**RE: 1401 Wyoming Blvd NE - Maverick**  
**Grading Plan Engineer's Stamp Date: 12/06/2018**  
**Hydrology File: J19D034**

Based upon the information provided in your submittal received 12/07/2018, the Grading and Drainage Plan cannot be approved for SO-19, Building Permit, or Grading Permit until the following conditions are addressed.

**DRAINAGE REPORT  
For**

**Maverik Fuel Center**

## SECTION A-A

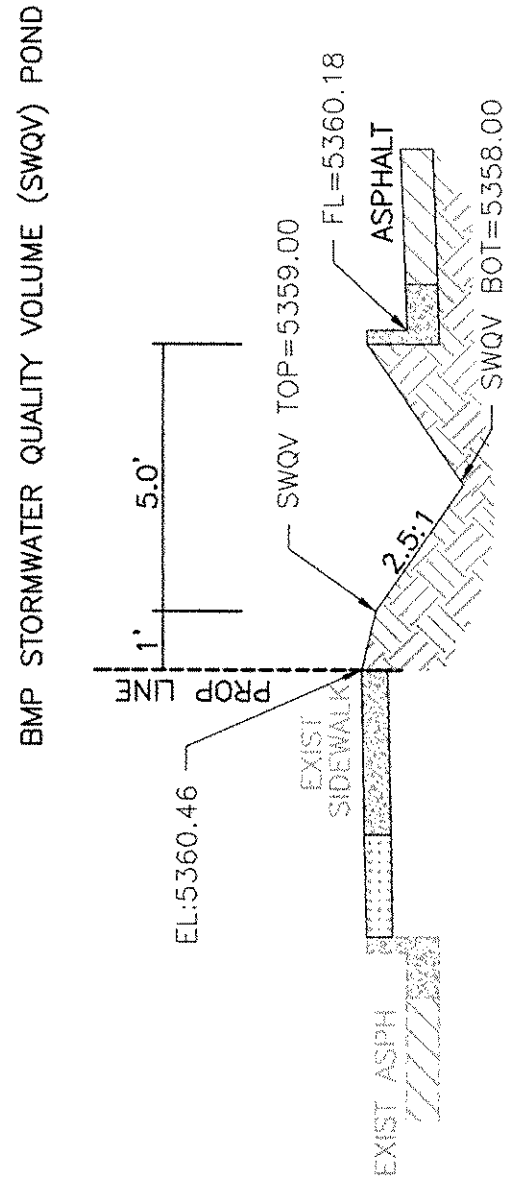
6. Pond #1 grades are problematic because the adjacent grade changes elevation by more than 4' from the low west end to the high east end. Retaining walls will likely be required, and must be shown in more detail. Section A-A shows a 2.5' elevation difference from top of slope to bottom of slope which makes the side slopes 1:1 instead of the 2.5:1 that is shown on the section. The pond is may be in a PUE so there may be franchise utilities in the way.

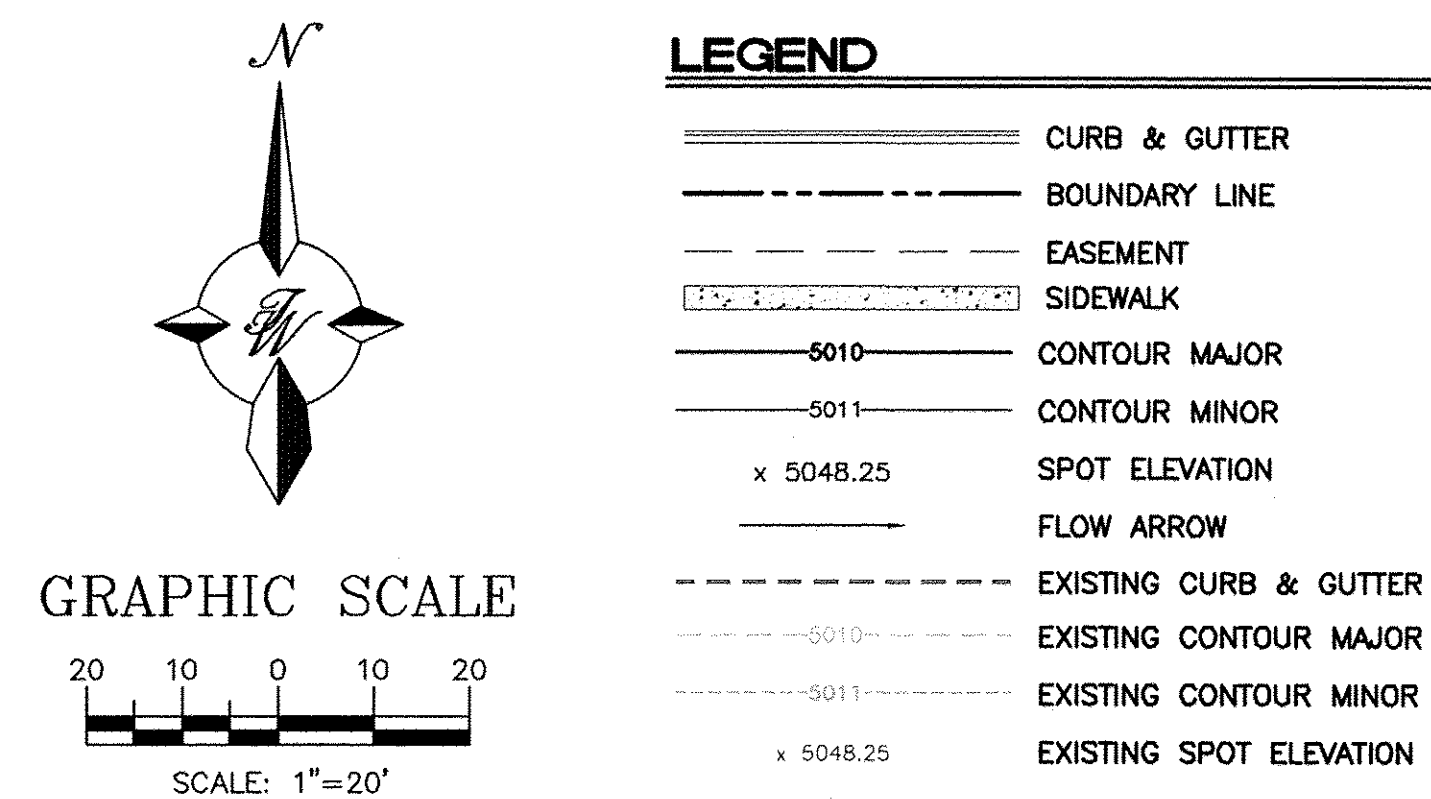
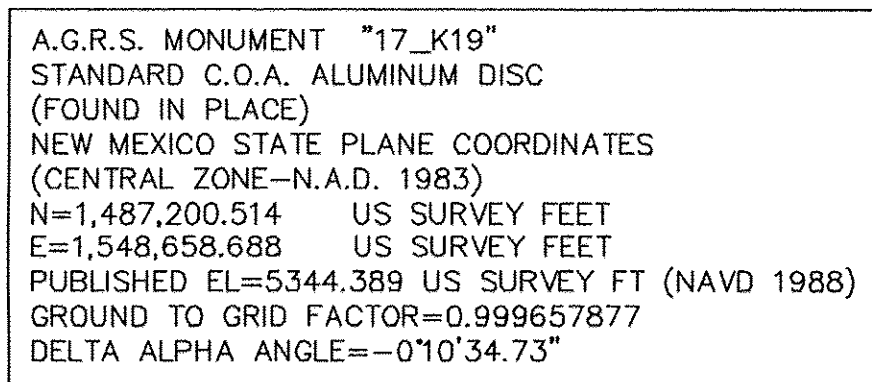
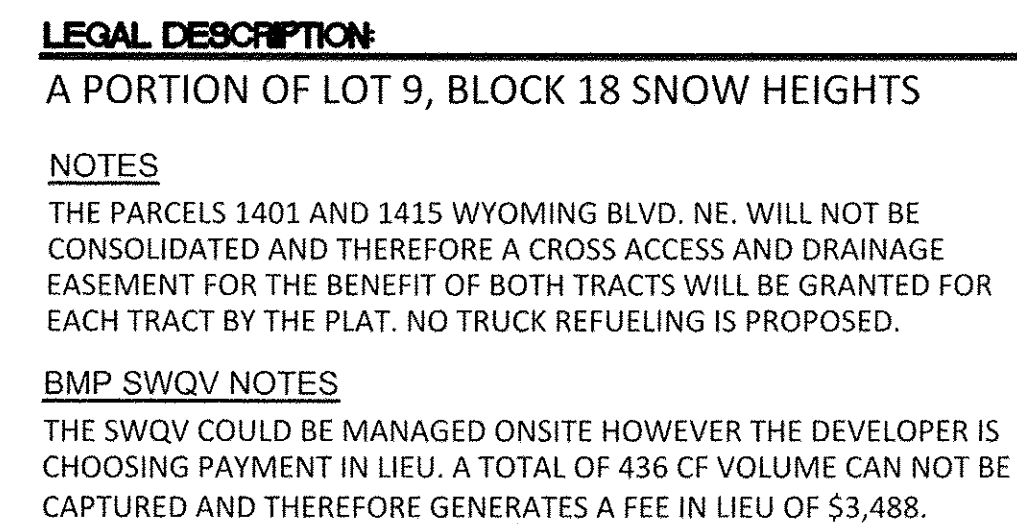
1. Note 8 on sheet C-2 does not apply to this site. Add standard SO-19 notes available on the hydrology web page unless a work order is required.
2. The sidewalk culvert may be eliminated if the 100 year overflow from the BMPs is directed through the parking lot to the west driveway.

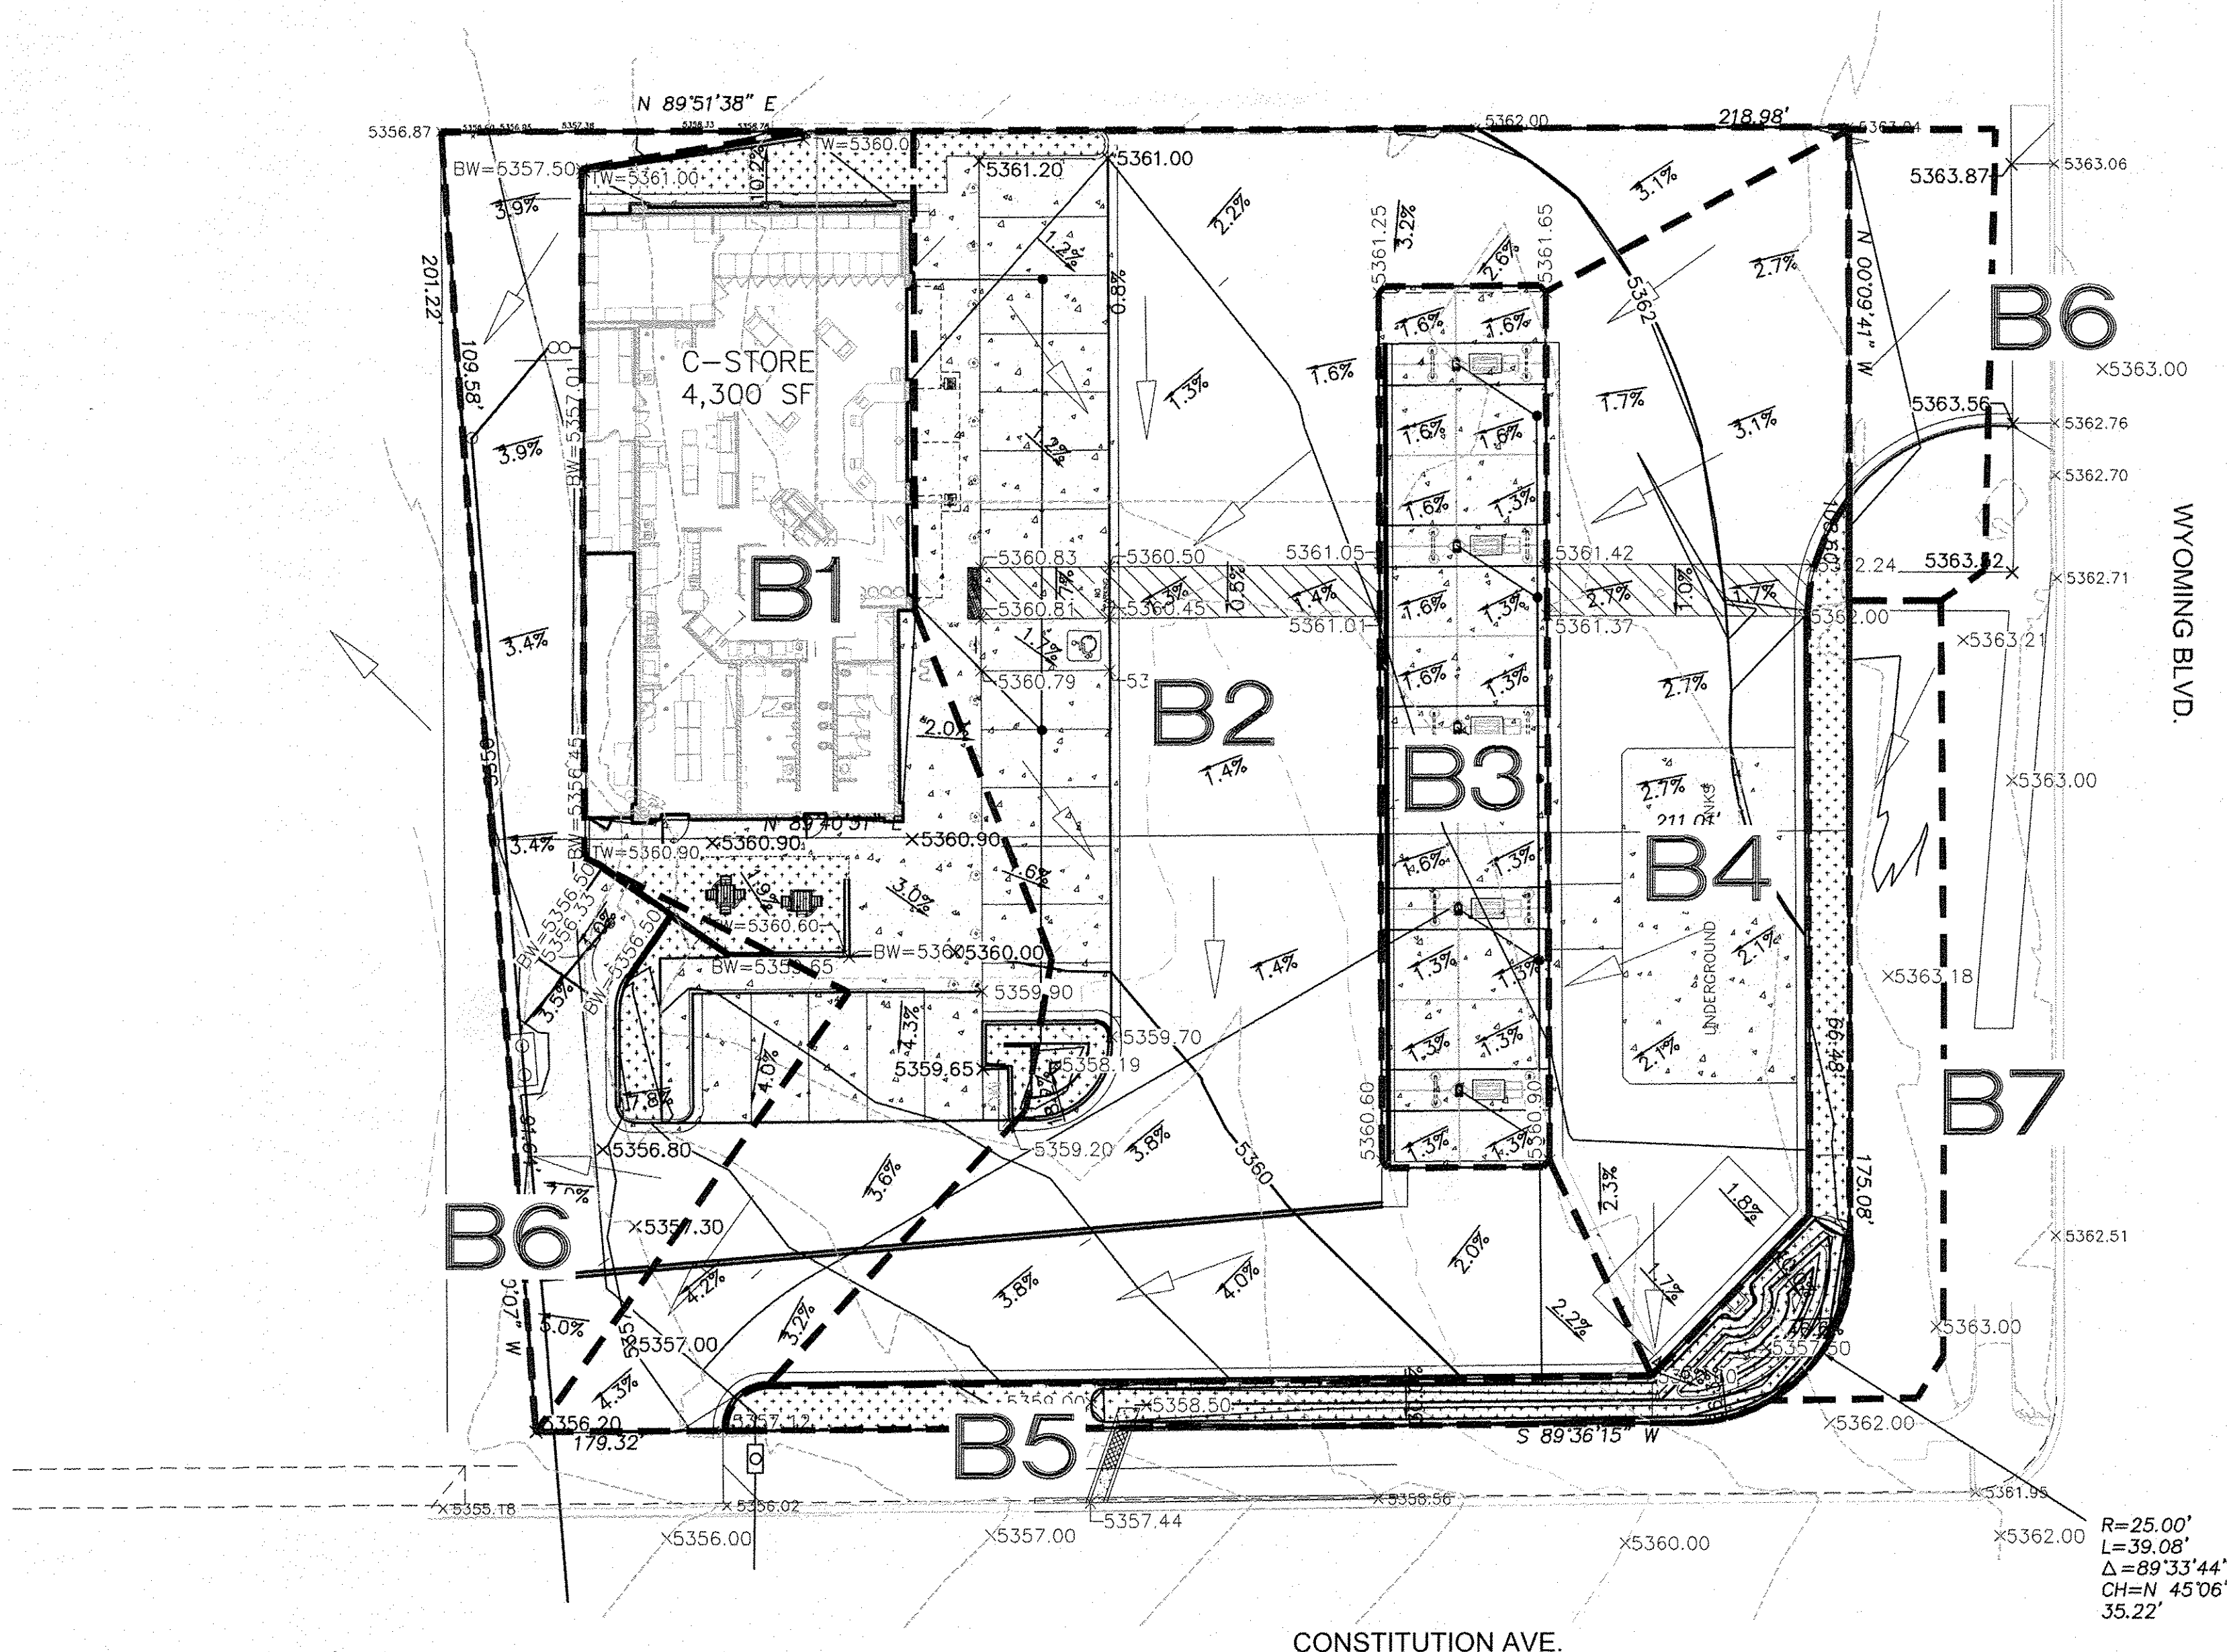
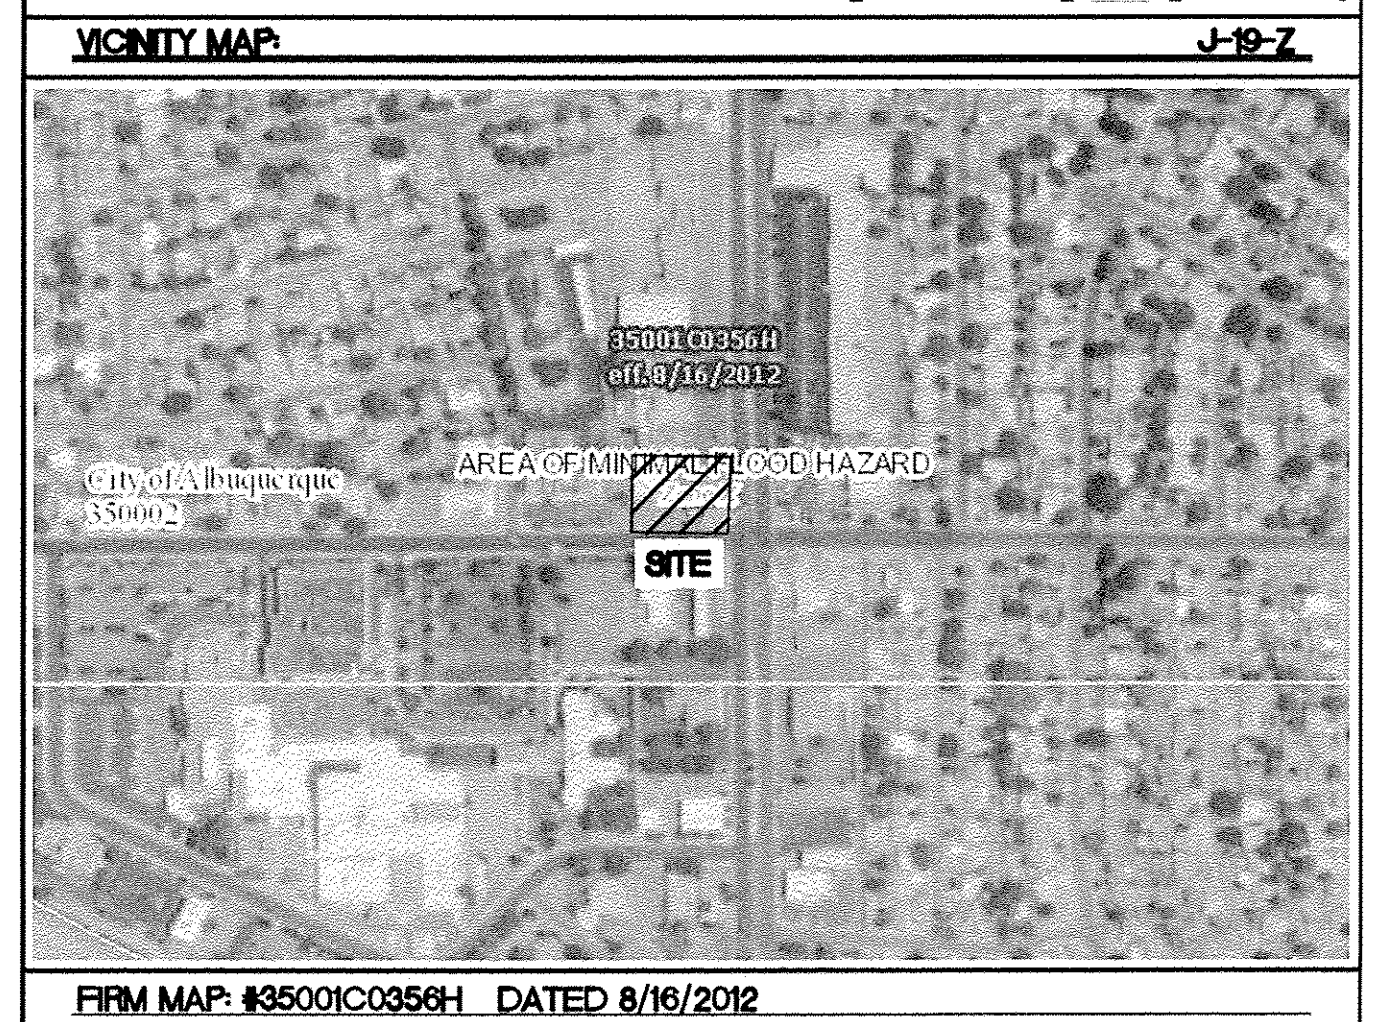
10. Since all of the new impervious surfaces can drain through BMPs, the statement in the SWQV BMP NOTES on sheet D1 should say "is not being captured" instead of saying "cannot be captured".
